Brookhaven National Laboratory
Plant Engineering - E&CS Division
Engineering Change Notice Form

PROJECT: CCWF II **JOB No.** 11705

ECN Title: MCC-600-3, EF-6 **ECN No.** 48

Affected Documents: E-604

MCC-600-3 ONE LINE DIAGRAM

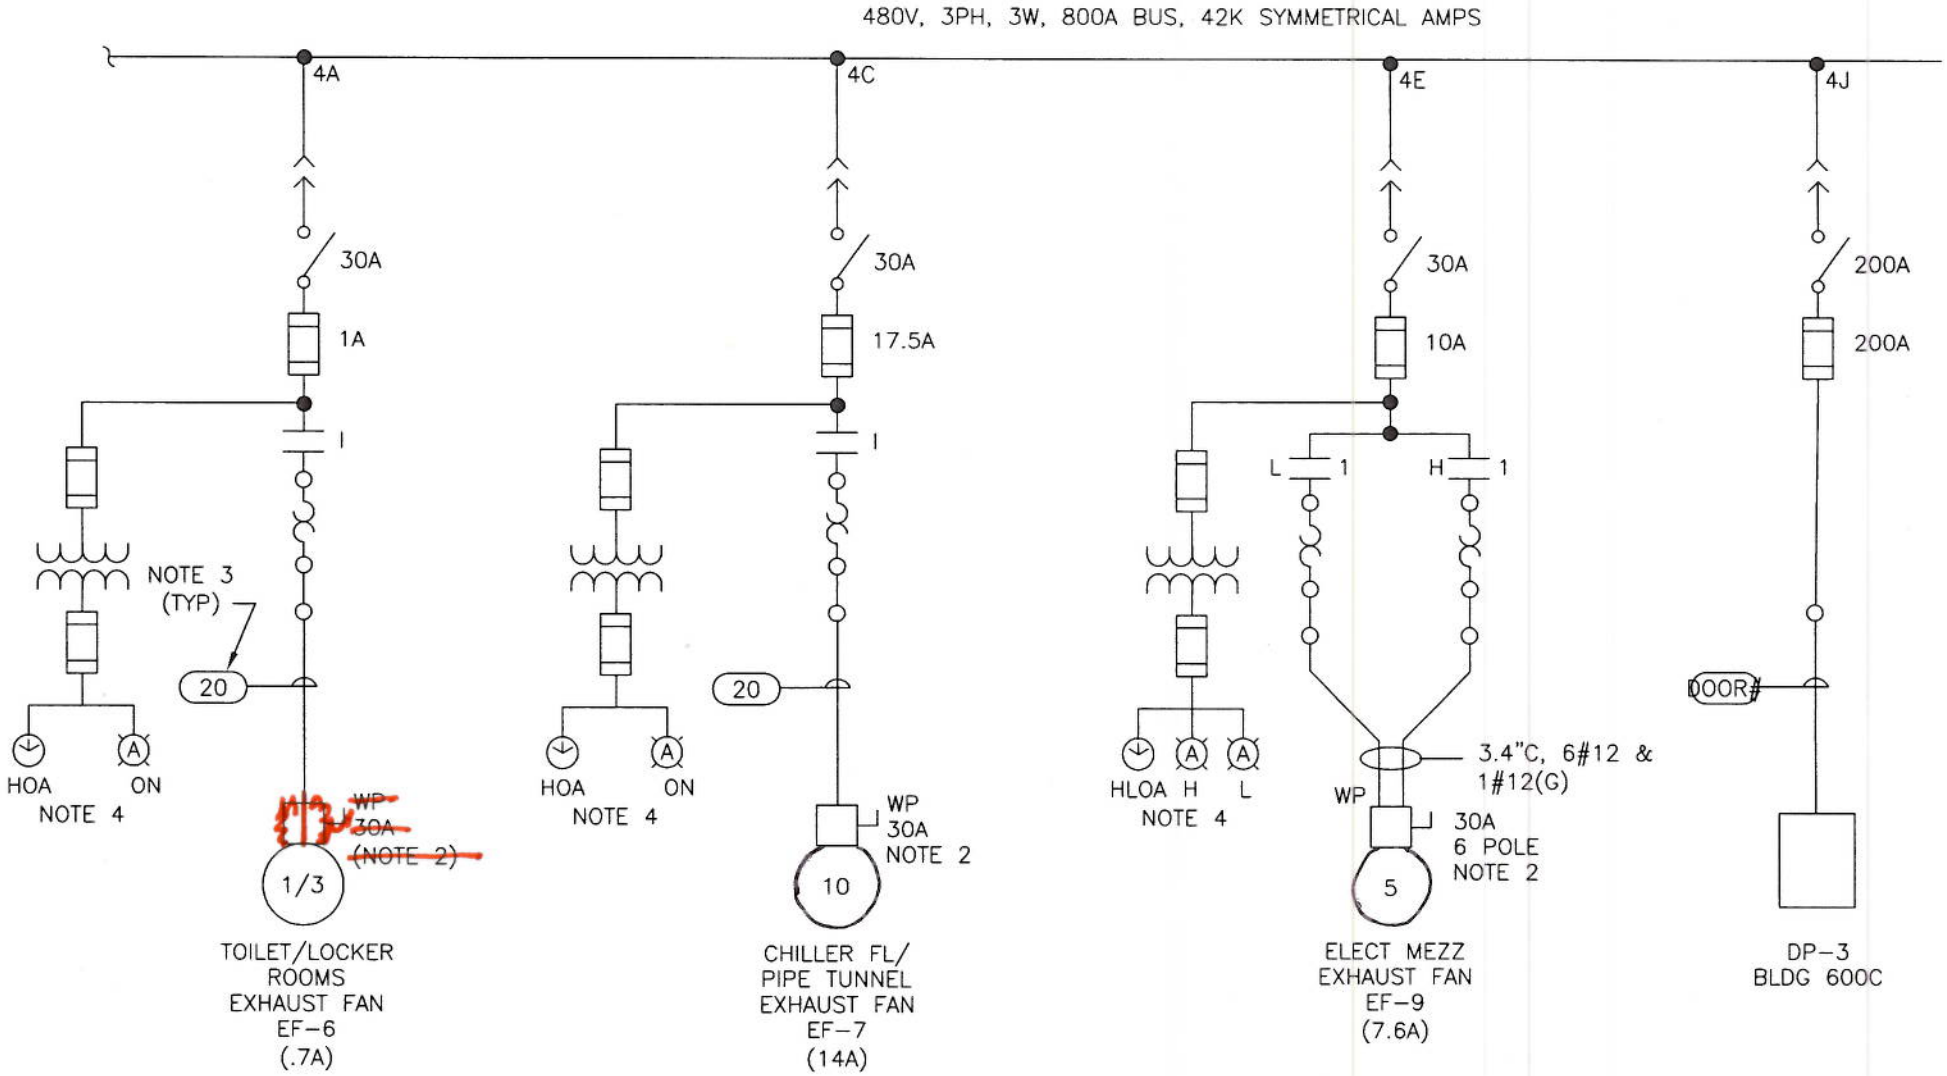
Requested Change (Attach sketch if applicable): Delete 30A local disconnect switch at EF-6. Wire from MCC-600-3 starter bucket directly to EF-6. There is no where to mount the disconnect switch, and NEC 430.102(B)(1) & (2) Exception (a) & (b) allows the motor disconnect to be deleted as long as the controller disconnect is capable of being locked in the open position.

Resolution: (See attached sketch)
